Technical Service Bulletin

70 Rattle from rear subwoofer grille

70 23 78 2044503/4 January 17, 2023. Supersedes Technical Service Bulletin Group 70 number 19-69 dated November 21, 2019, for reasons listed below.

Figure 3. Foam strip installation for vehicles with Bang and Olufsen (PR code 9VS)

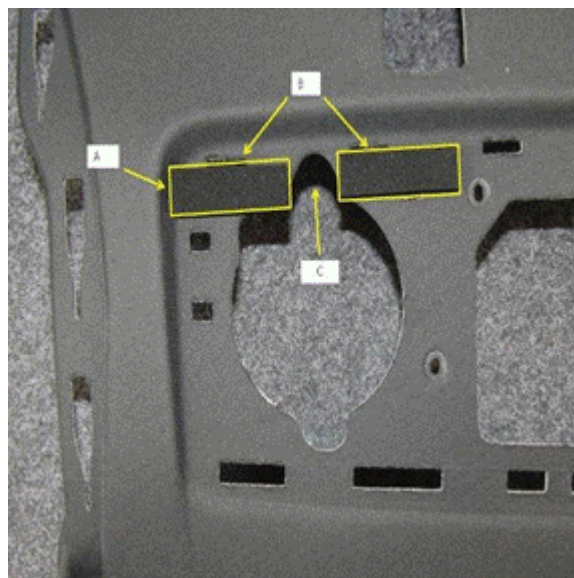
The rear parcel shelf speaker grille will rattle when loud music with heavy bass is being played.

Observe the following positioning (Figure 3):

- 2x damping strips 8E0 831 575 A (2x 70mm)

A = bond the damping strip on the edge.

B = bond on the rim of the perforation.

C = keep clear of the speaker section.
